CHANGE ORDER NO. 11

PROJECT: West Sewage Treatment Plant (STP) Improvements  
 OWNER: City of Crest Hill, Illinois  
 CONTRACT: 1-2022  
 CONTRACTOR: Vissering Construction Company

Cost Proposal Request  
West Sewage Treatment Plant Improvements  
City of Crest Hill  
Contract 1-2022  
August 26, 2025

**SHEET**  
174  
**E70-ASM1.01**

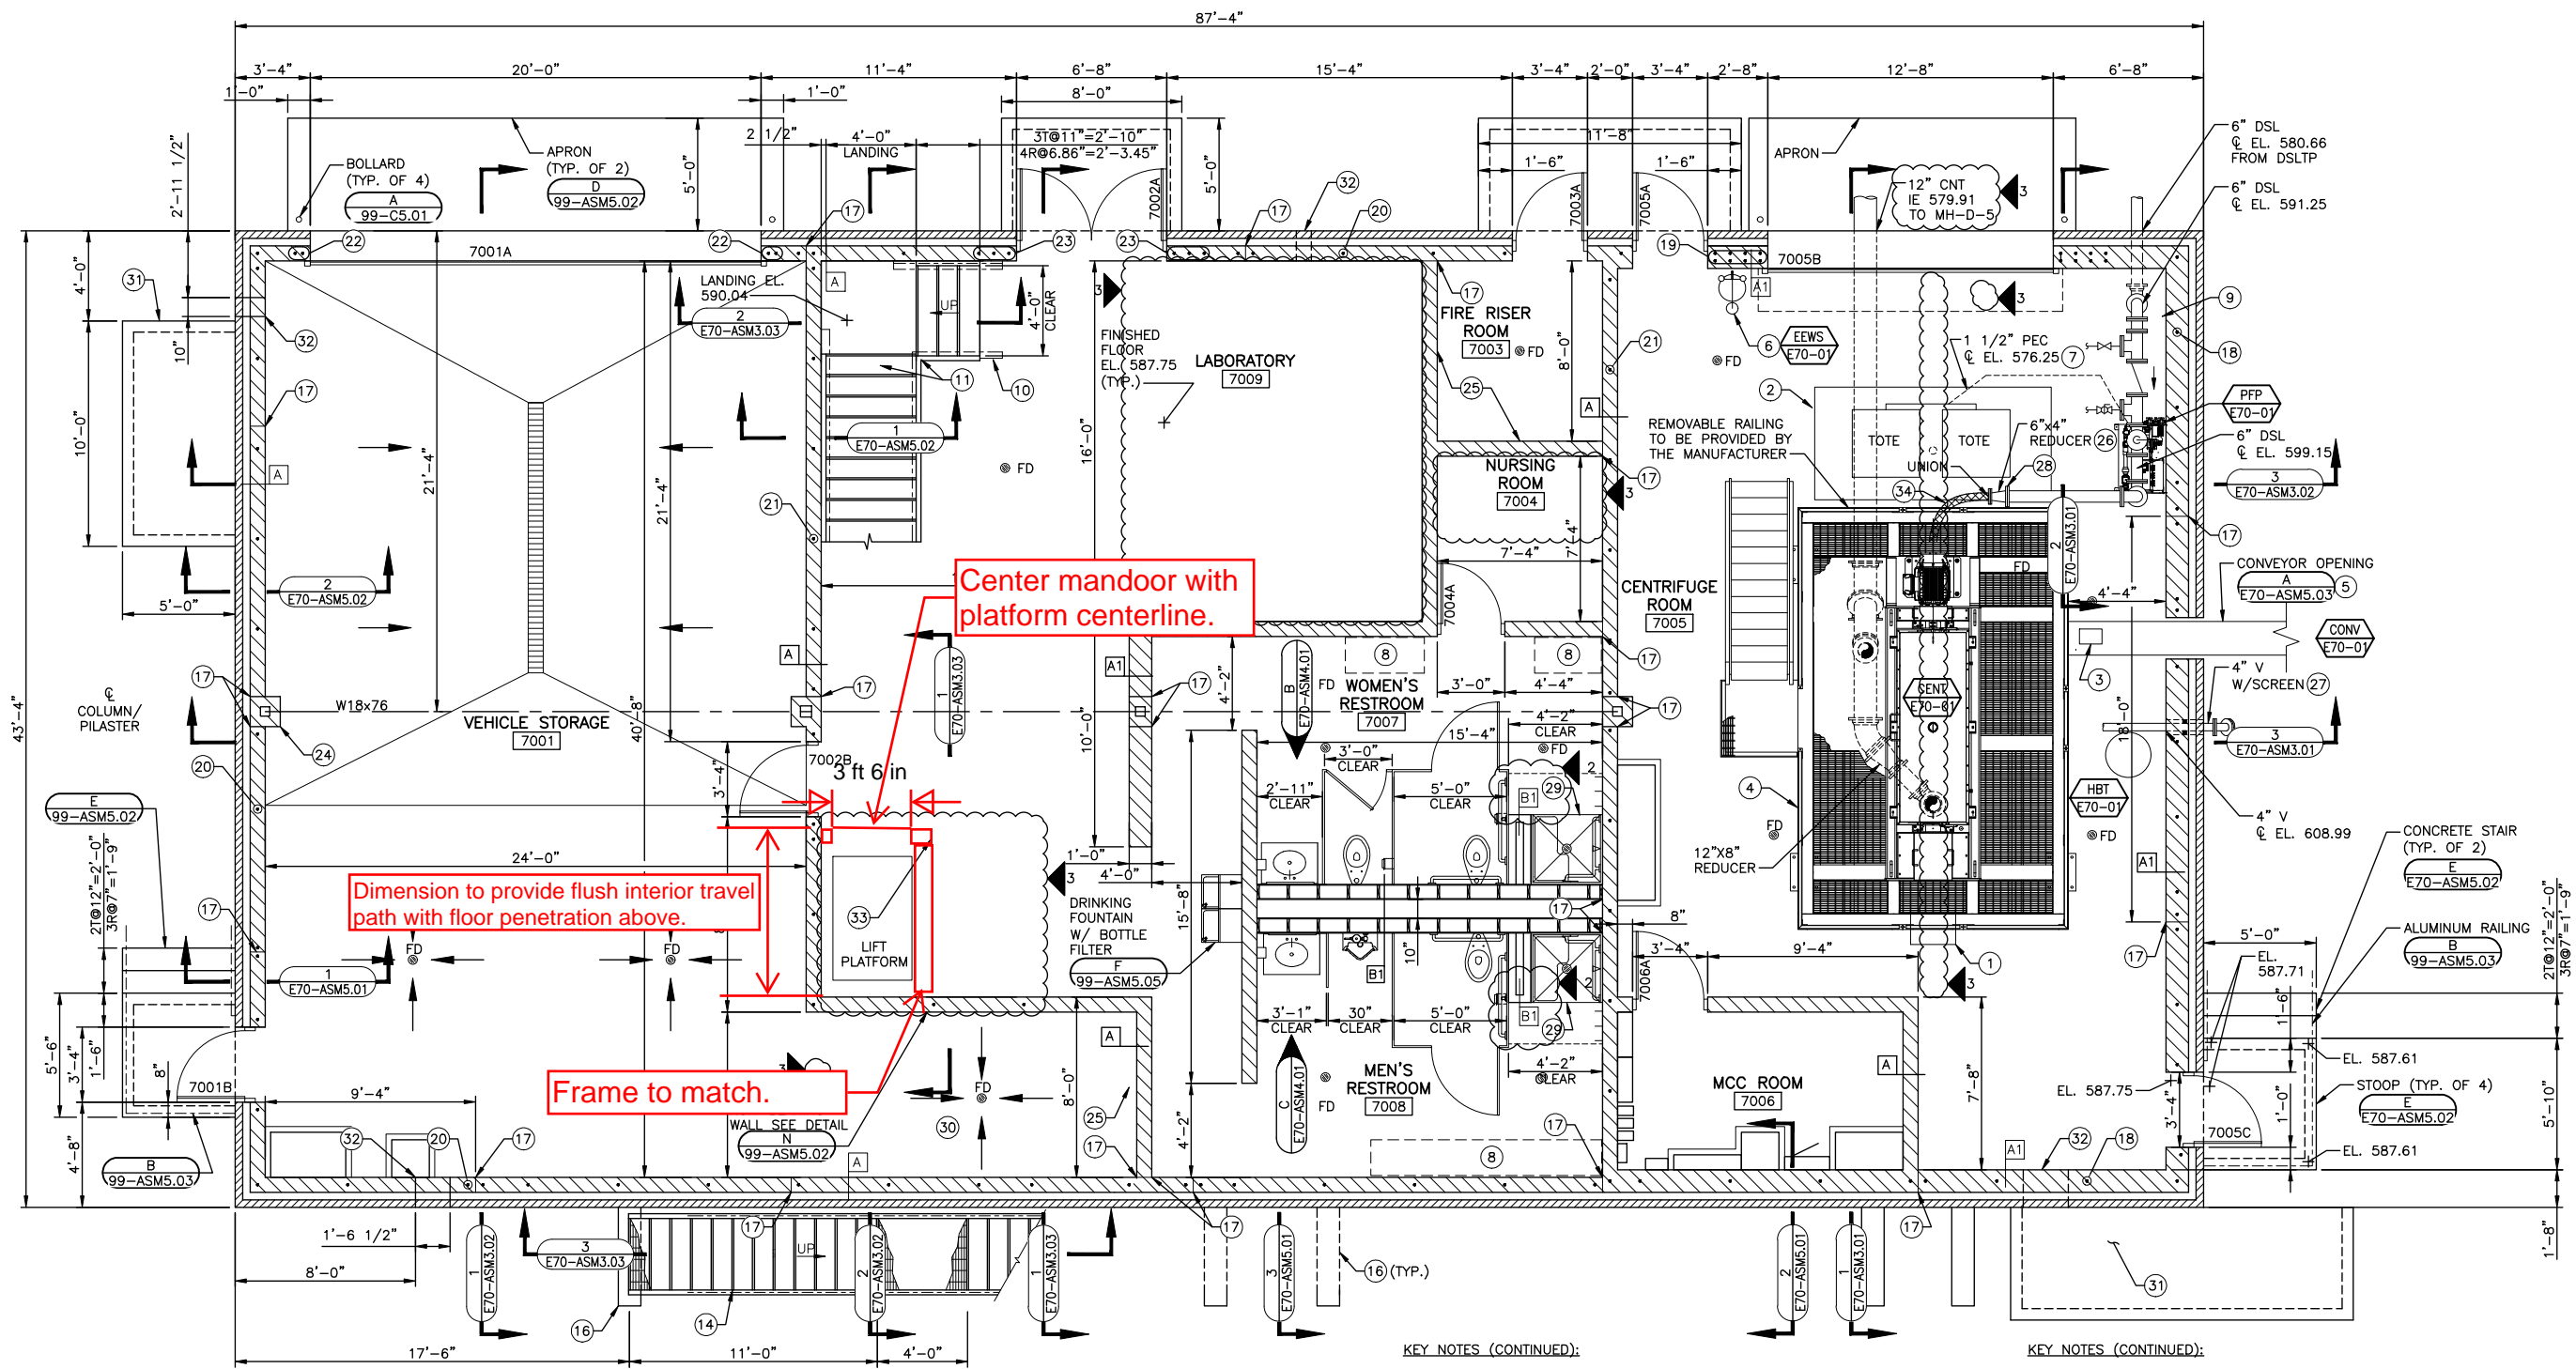
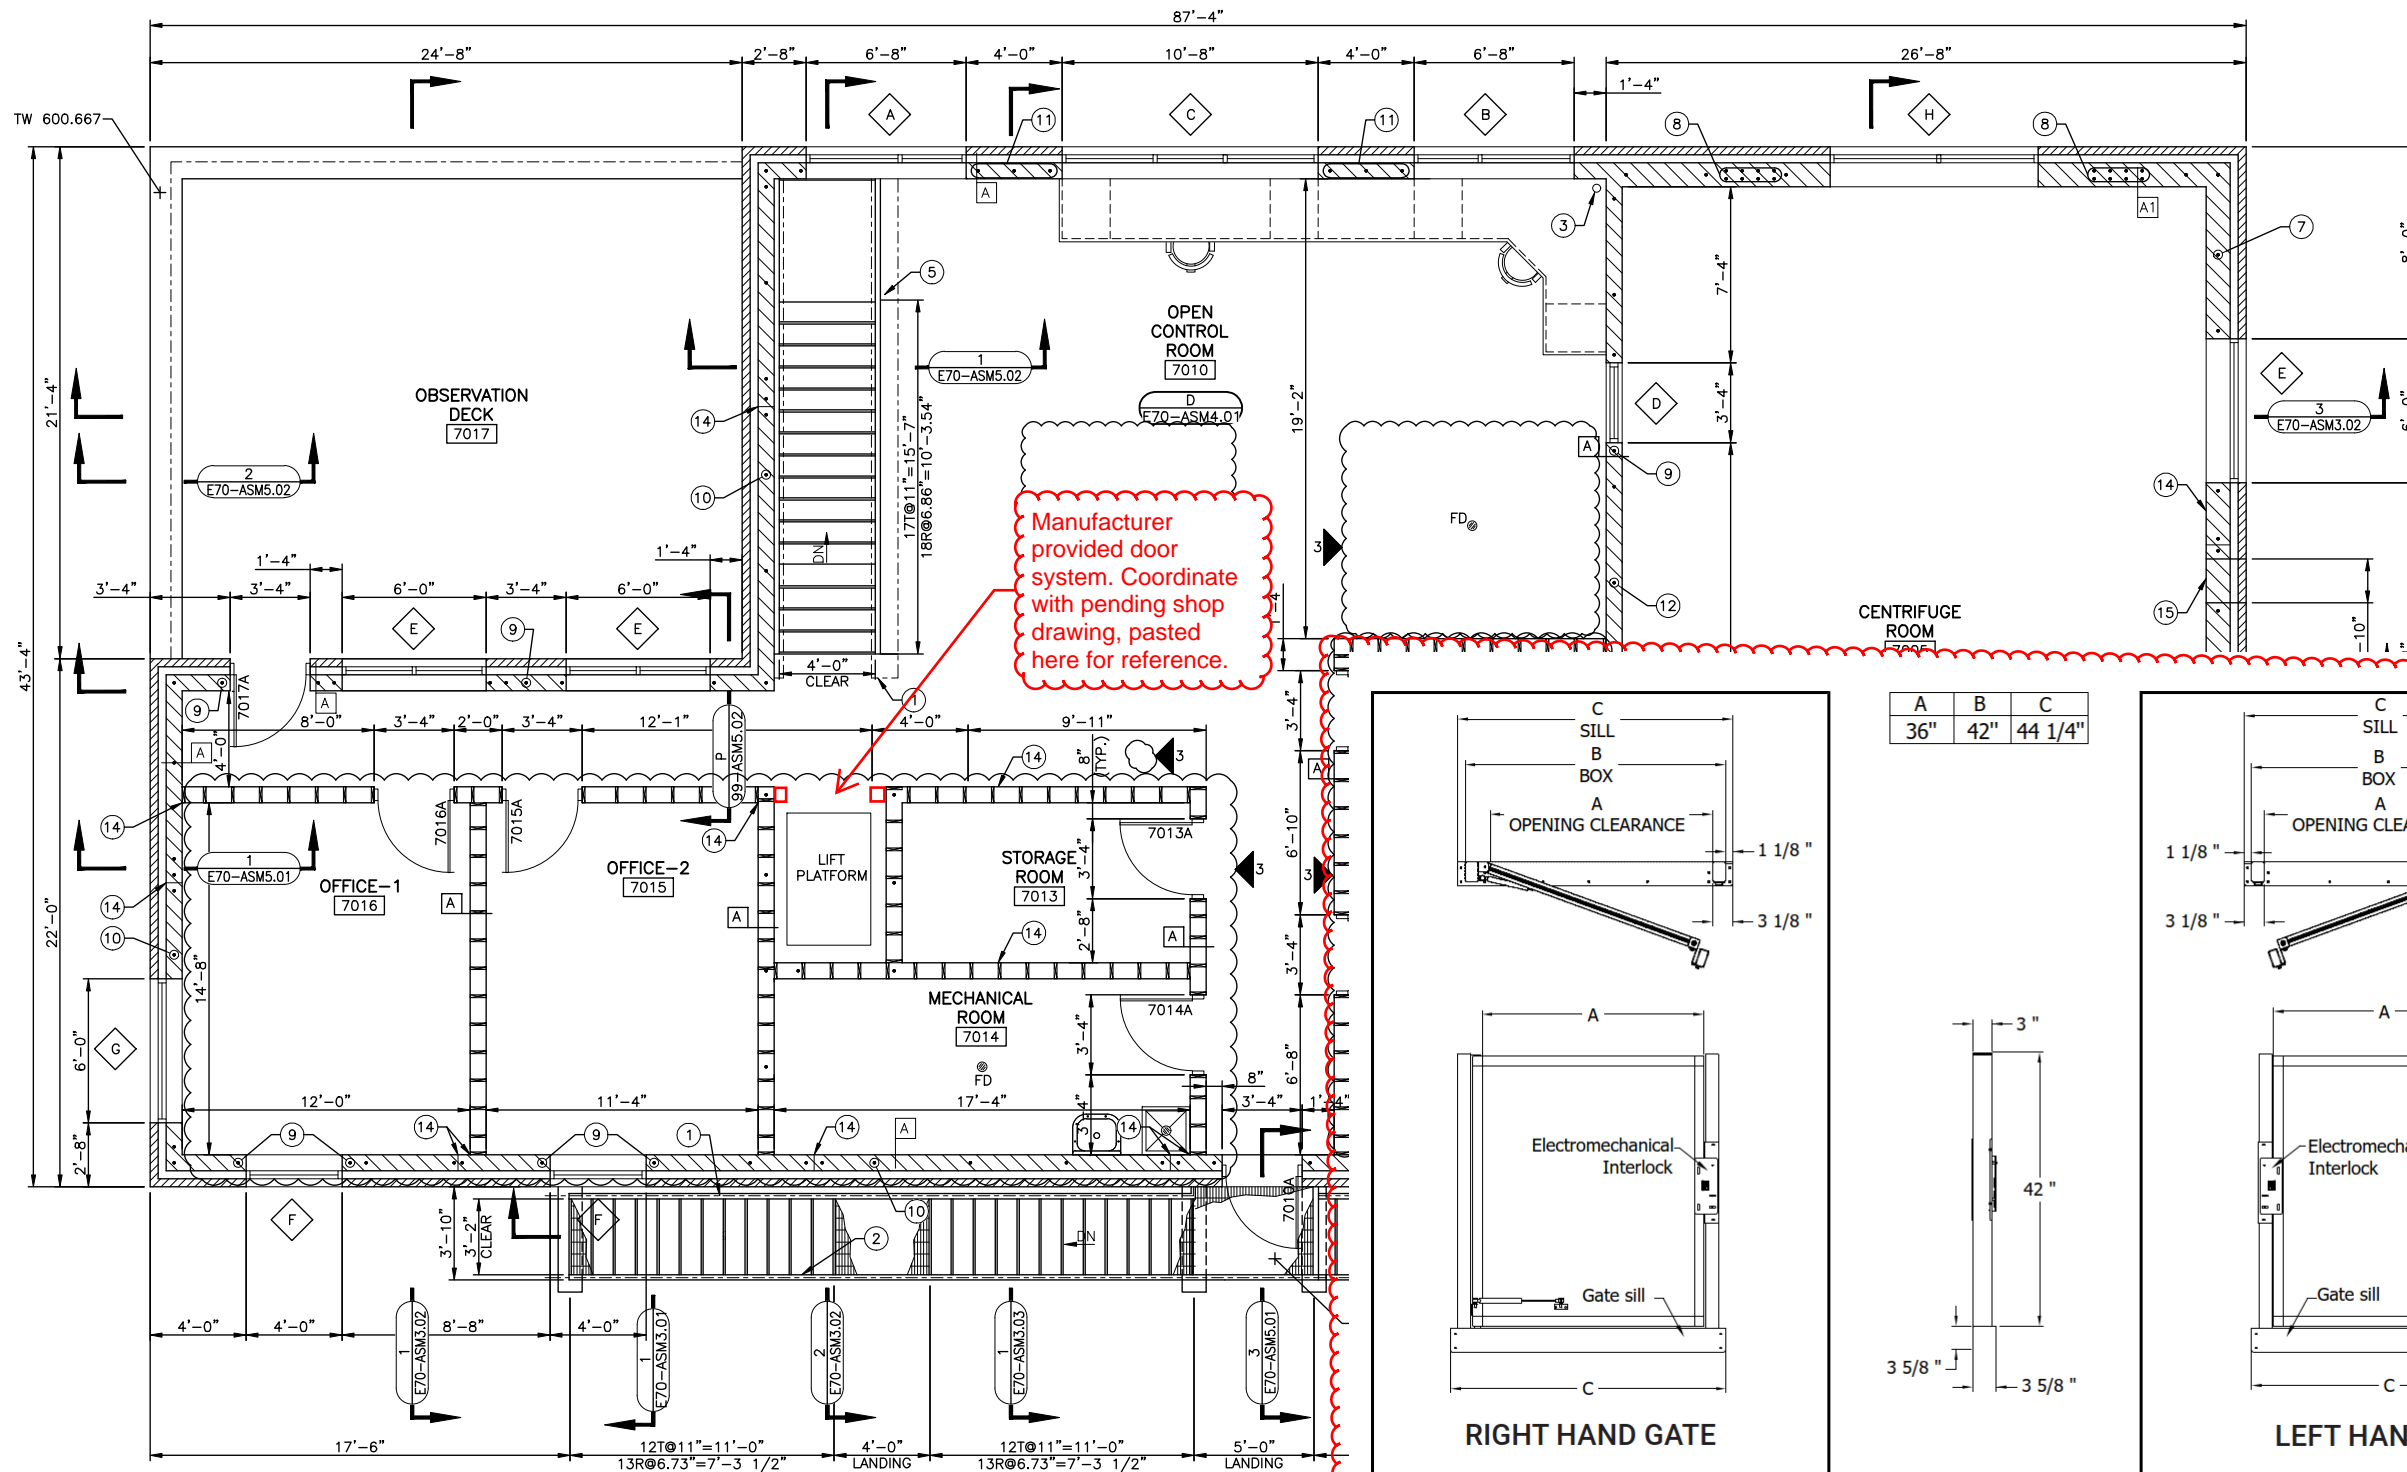
**Drawing E70-ASM1.01**

- 044-01 Frame and drywall the northern and eastern shaft fenestration surrounding the newly proposed door on the first floor. See attached drawing.
- 044-02 Change manufacturer provided first-floor half-height door with full height mandoor. Rewire electrical componentry from manufacturer-provided call-station to interlock doorway hardware (automatic door opener) with platform lift system operation, as described below.

Add row to Drawing 99-ASM6.01 Door 7002C, size 3'-6" x 7'-0", type - STL, active - HG, swing - RHR, frame type - 1, frame material - STL, hardware group - as provided by product manufacturer, active, lintel - B-1, Details, head - F-99-ASM6.02, jamb - F-99-ASM6.02, sill - N/A
- 044-03 Provide attached pictograph (Attachment A) at first floor and second floor call stations. Pictograph shall conform to Section 10 14 00 - Plastic and Metal Signs.

SHEET  
175  
E70-ASM1.02

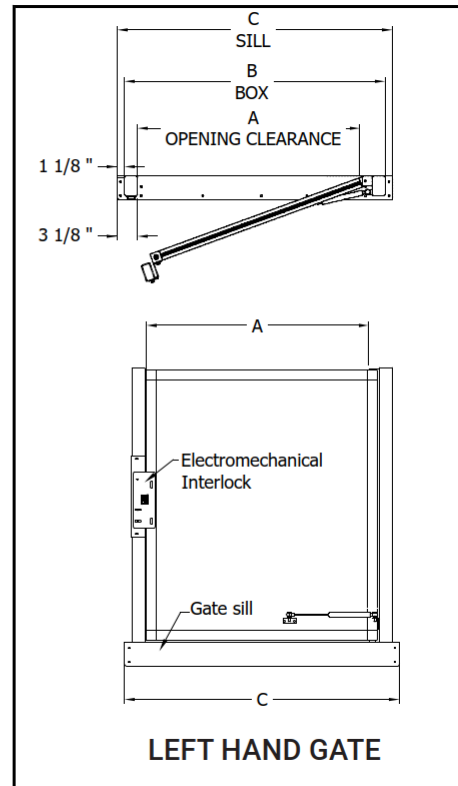
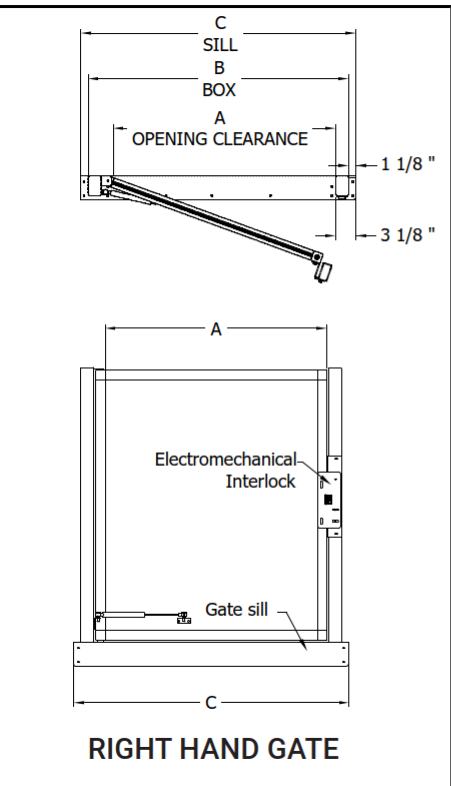
**Drawing E70-ASM1.02**

- 044-04 Frame northern shaft fenestration on second floor. See attached drawing. Standard manufacturer-provided door, its respective wiring, and call-station shall remain at the second floor.
